Response to submissions

St Peters concrete plant and materials handling facility - Modification 11

Prepared for Boral Resources (NSW) Pty Limited | 11 September 2018

Proposed modification
 Response to submissions
 Modification 11
 Borl St Peters
 Figure 2.1

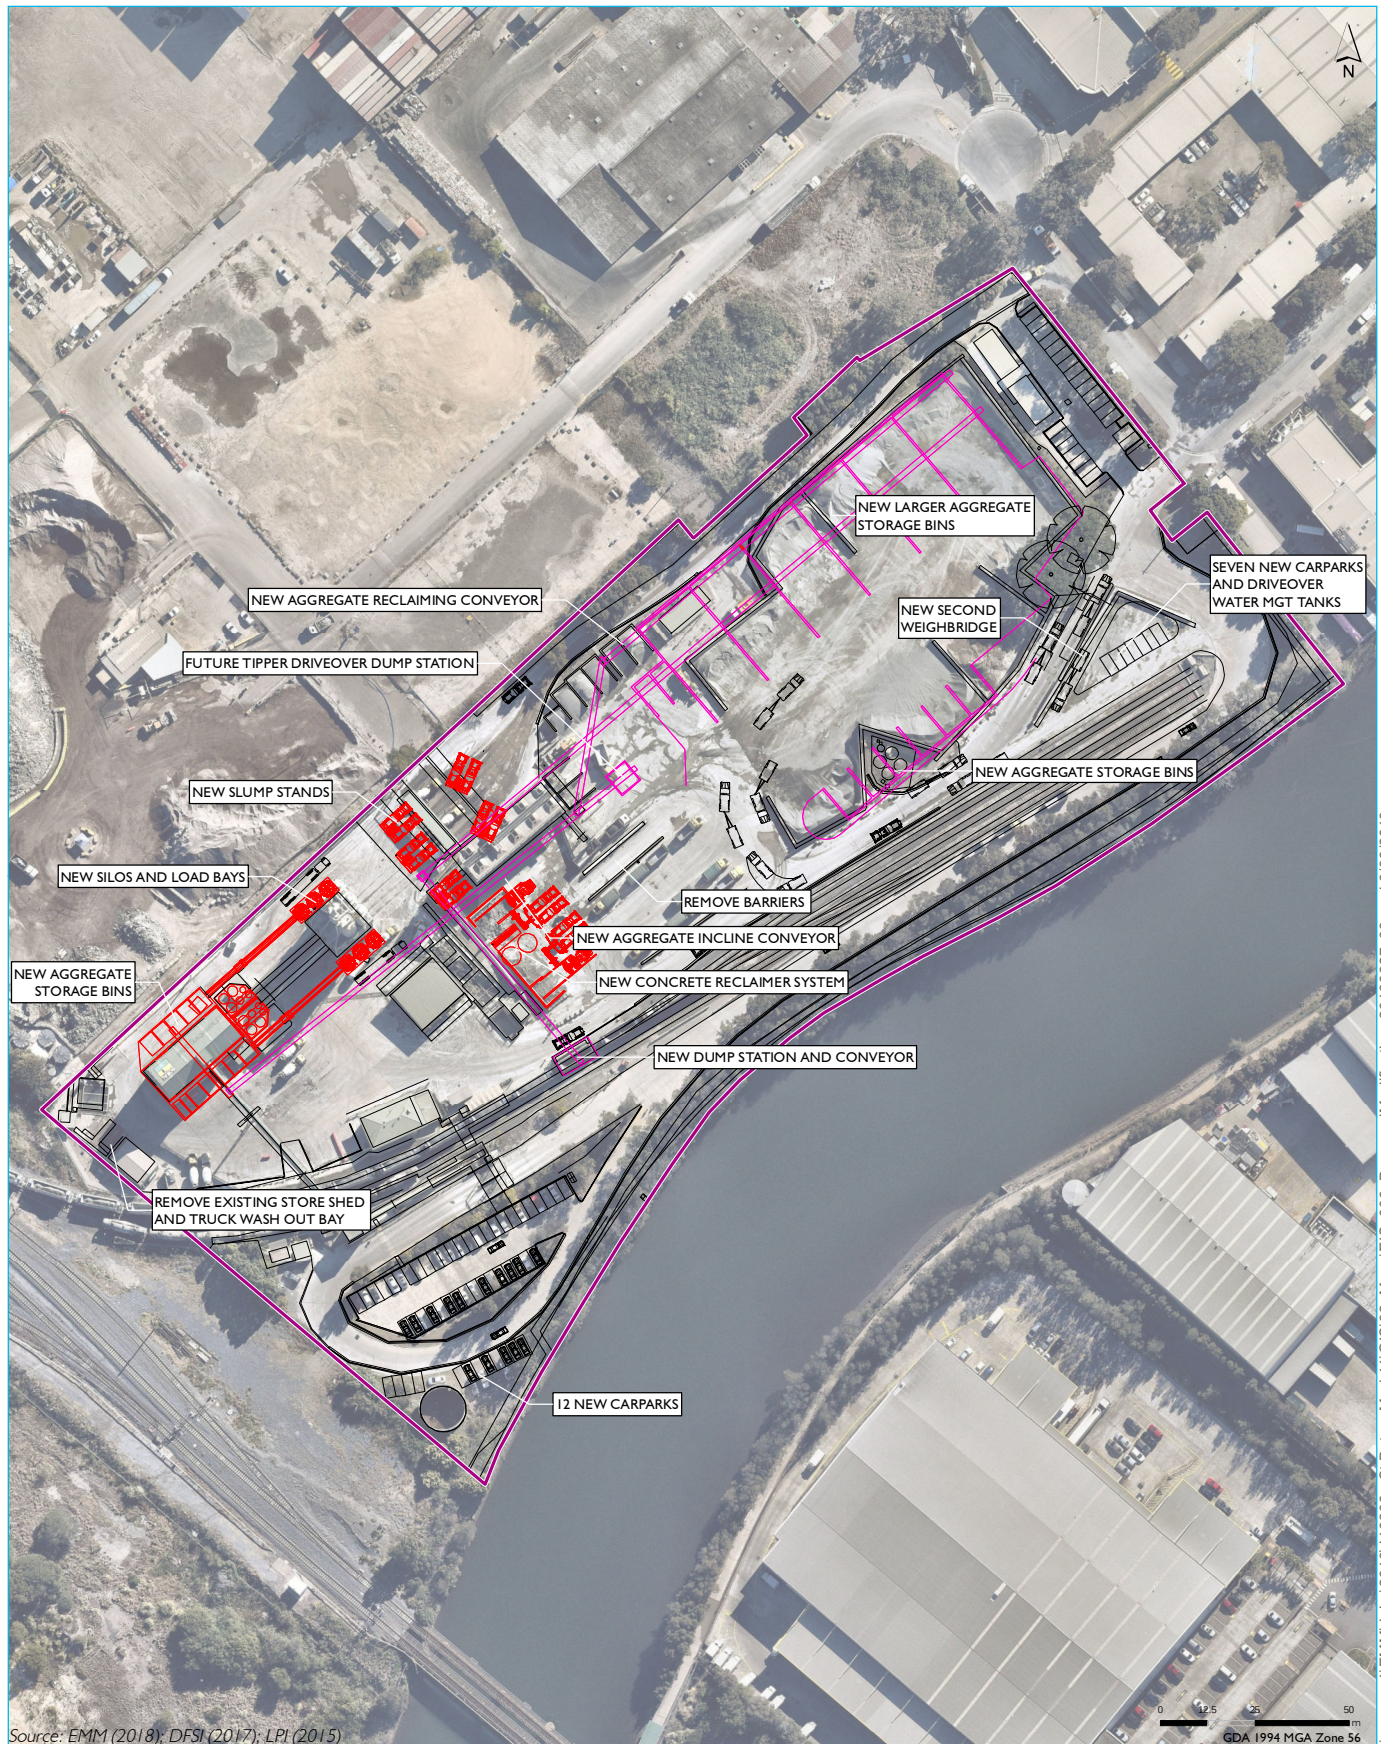
DPE asks for further clarification with respect to the number of additional slump stands. Section 3.3 of the St Peters Mod 11 EA states there are two additional stands, however, Figure 3.1 appears to show three additional stands.

DPE asks for further clarification with respect to the additional slump stands. It is also unclear whether there are two or three additional double position slump stands. Section 3.3 of the St Peters Mod 11 EA states there are two additional stands, however, Figure 3.1 appears to show three additional stands.

Figure 5.1 MOD 10 vs MOD 11 operational emission comparison

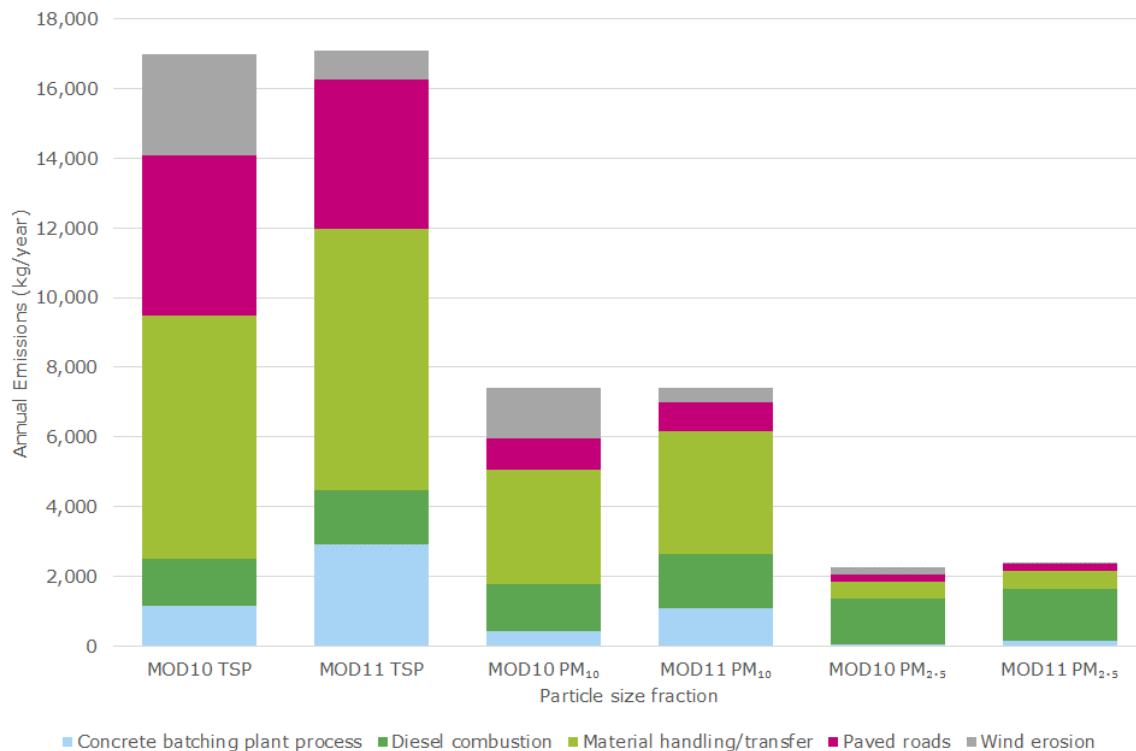
DPE refers to Section 6.4 of the AQIA that provides a comparison of the emissions from the proposed modification with the emissions calculated for the MOD 10 site operations. DPE requests *"a table which quantifies the changes in emissions illustrated in Figure 6-3 and Table 6-1, showing both existing (MOD 10) and predicted (MOD 11) annual emissions numerically and in percentages."*

As requested by DPE, the following table provides a source by source breakdown of annual emissions and the relative change between MOD 10 and MOD 11. It is noted that due to changes in site processes associated with MOD 11, not all emission sources are applicable for both MOD 10 and MOD 11. In these instances, the difference is either +100% or -100%.

also extended into Figure 6-3 of the AQIA. The revised Table 6-1 and Figure 6-3 is presented below in Table 5.1 and Figure 5.1 respectively.

**Site: 101 [Canal Road/Burrows Road/Ricketty Street AM Peak 2017]**

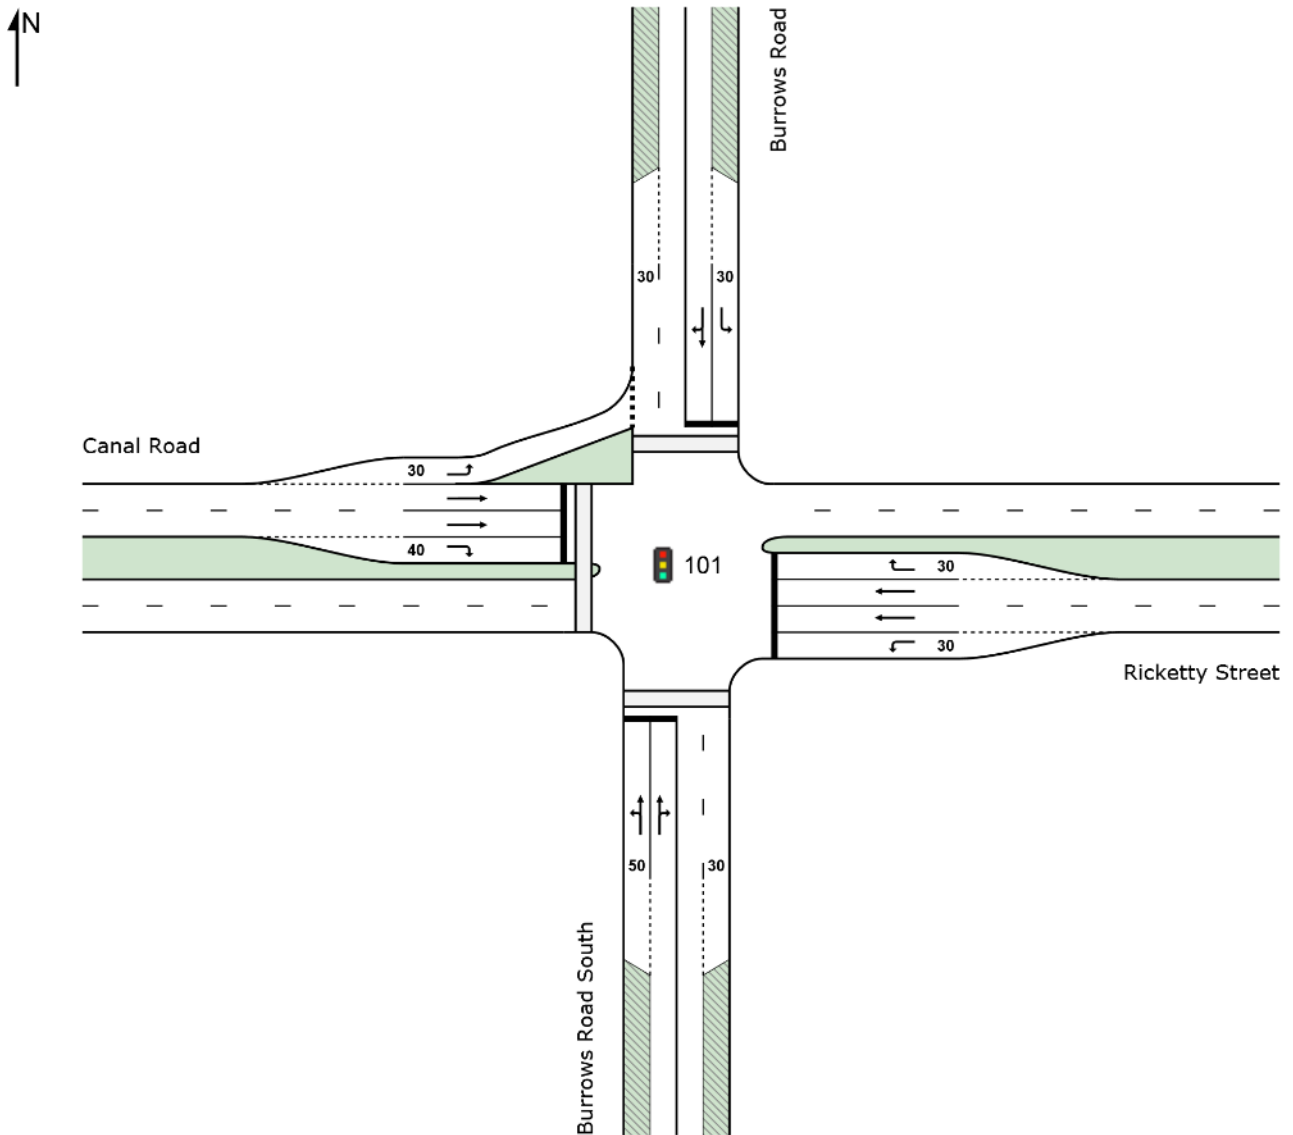
DPE notes that ...*"Given the predicted increase of up to 42.9% in traffic movements on Burrows Road South as a result of the proposed modification, the Department supports Inner West Council's recommendation for Boral to upgrade Burrows Road South (refer to Council's submission dated 10 August 2018) between the site exit driveway and the intersection with Burrows Road, Canal Road and Ricketty Street"*

The above results show that the most appropriate solution is the optimal phasing scenario with the extended “No stopping” zones in the short term until WestConnex is operational and improves the local road network in this area. See Appendix B for full SIDRA modelling results.

This is a key impact of the Project and Boral notes that there are intersection operation issues with the very short "No Stopping" zones on the Burrows Road (north and south) approaches to the intersection with Ricketty Street/Canal Road. This situation is exacerbated in the early mornings due to the illegal parking of trucks along Burrows Road South, which is used as a de-facto marshalling area by various transport companies not associated with Boral's operations in the area. Observations show that numerous trucks park in the "No Stopping" zones and across driveways overnight.

Client	BORAL RESOURCES (NSW) PTY. LTD.		Drawn	RF	Scale	NTS
Project	St Peters Concrete Batch Plant Mod 11		Designed	RF	Date	11/03/18
Title	North East Elevation		Checked	RF		
			Size	Drawing No.	Sheet	Revision
			A3	STP002	2	1

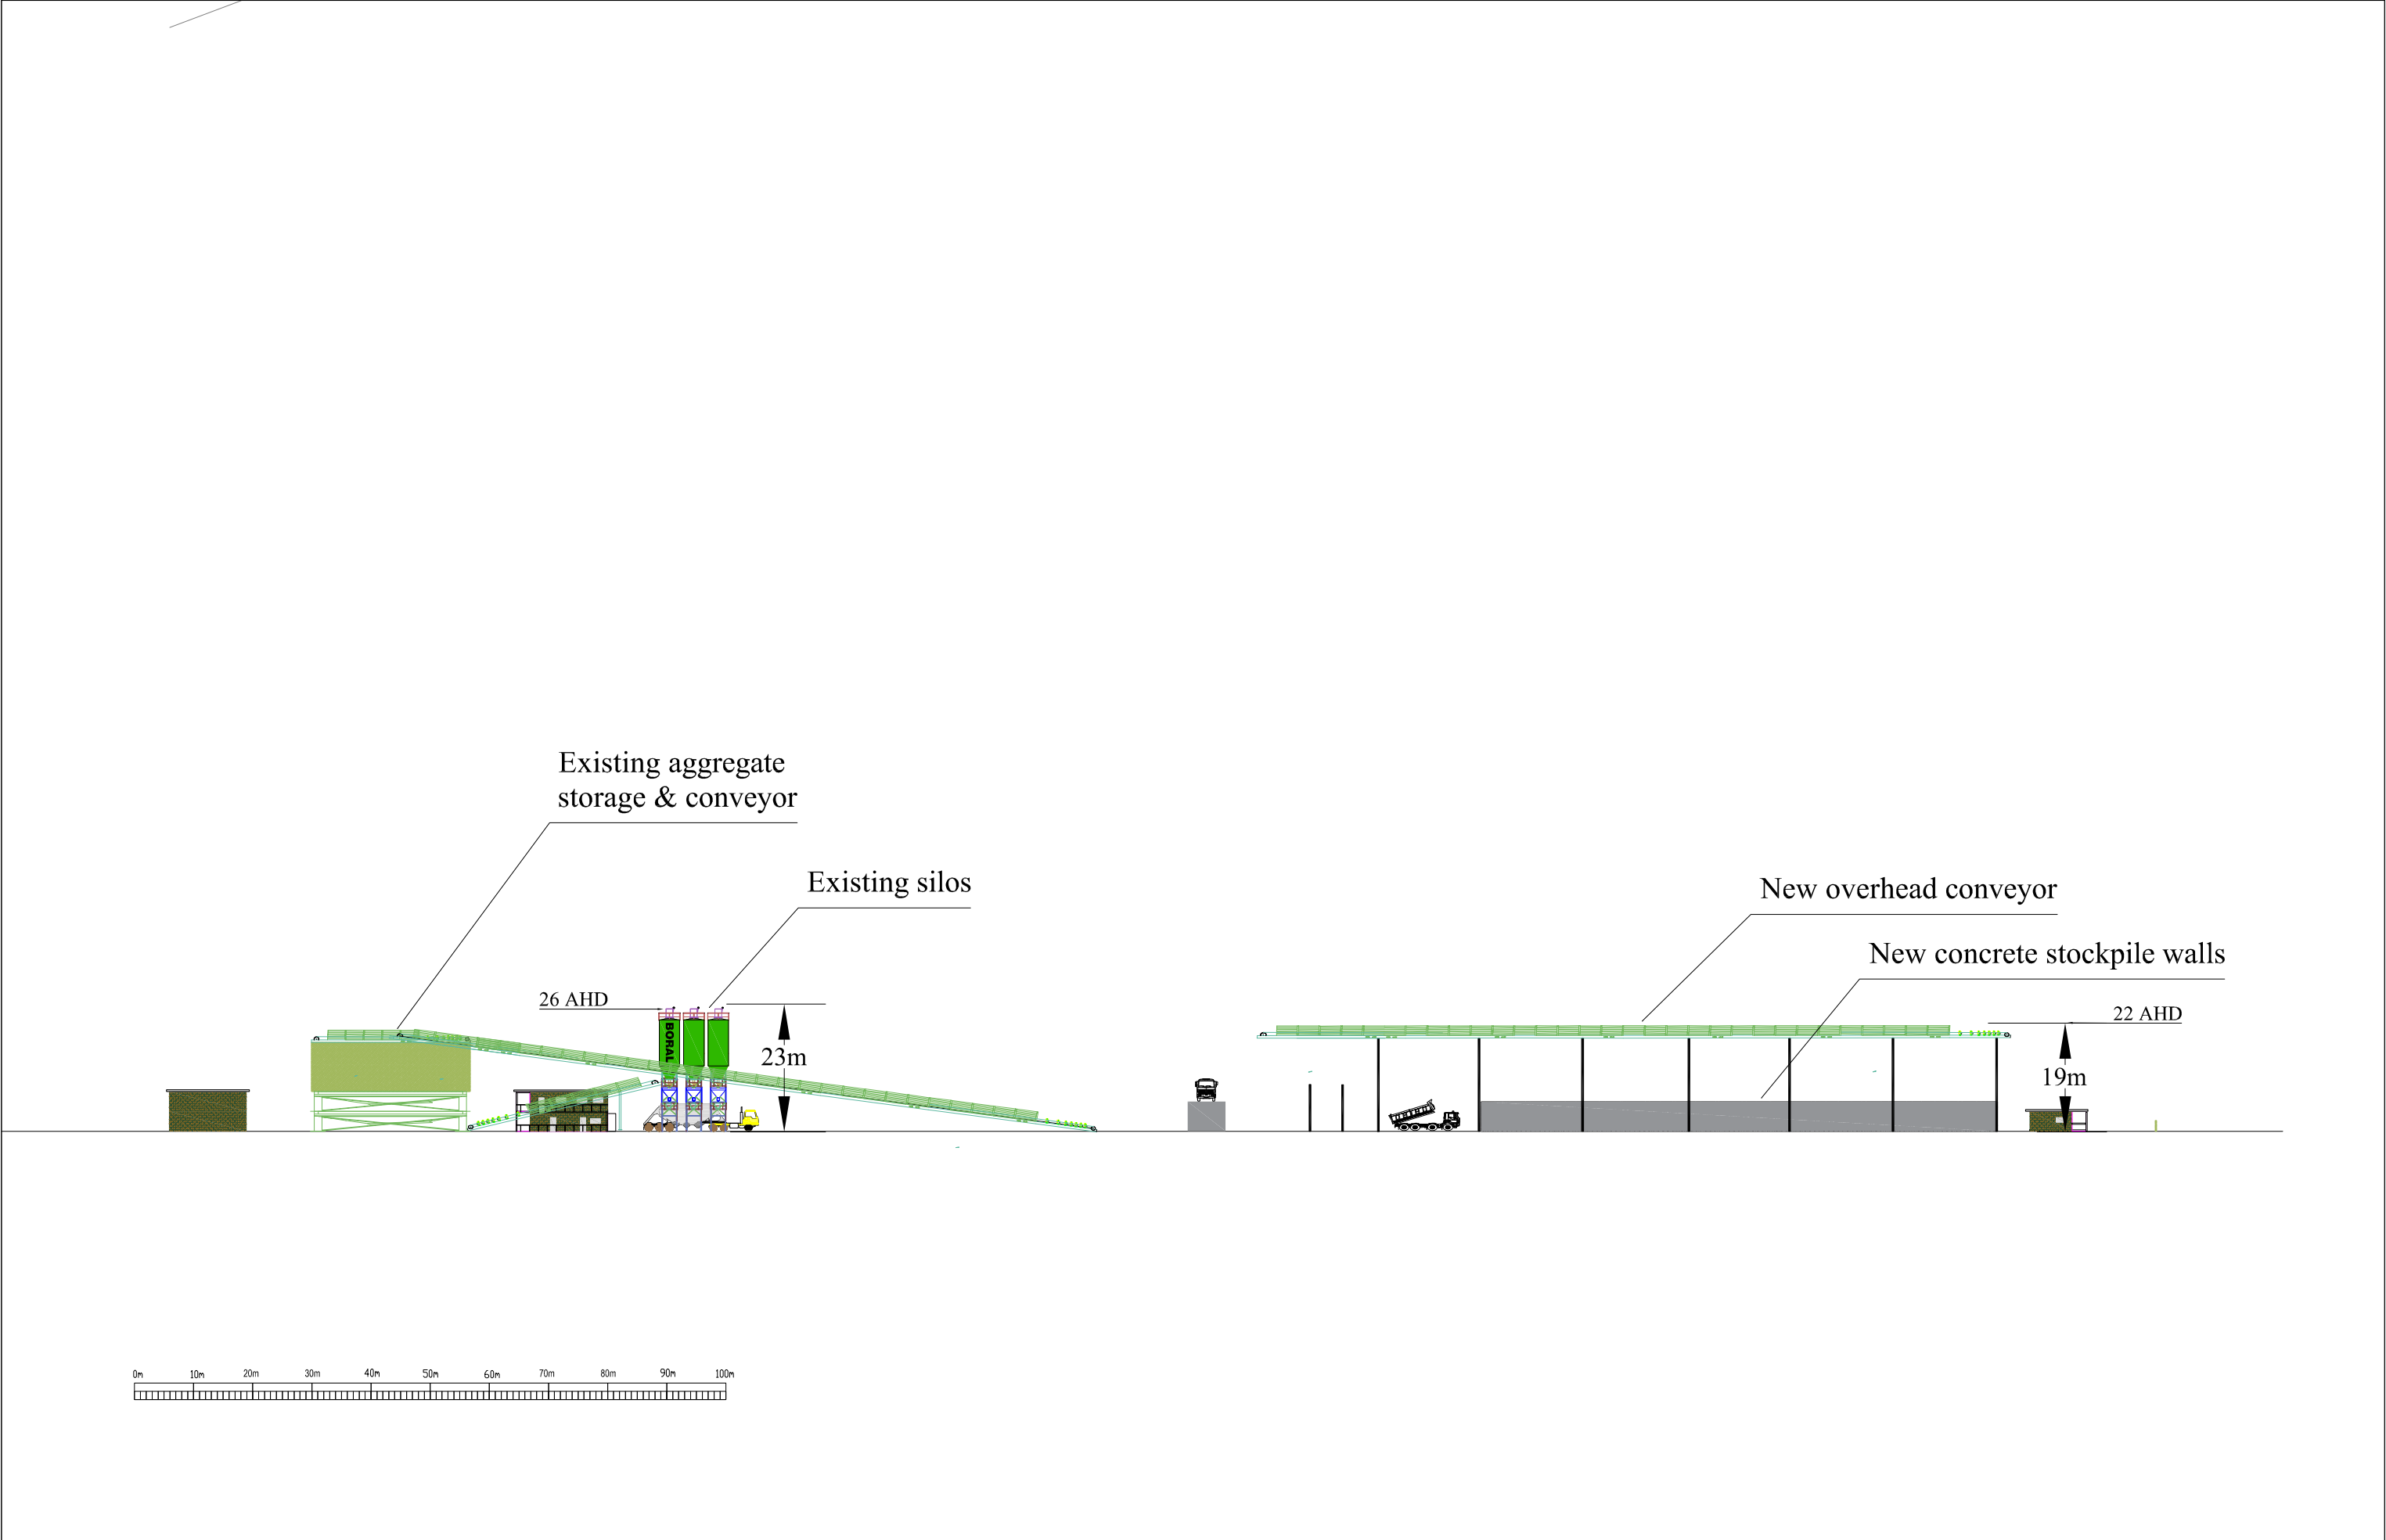
DPE requested A3 versions of site layout plans. A3 versions of the site layout plans (Appendix C) were included in Version 3 of the St Peters Mod 11 EA, provided to DPE on 17 July 2018.

Copies of the A3 plans will also be provided in Appendix D of this RTS.
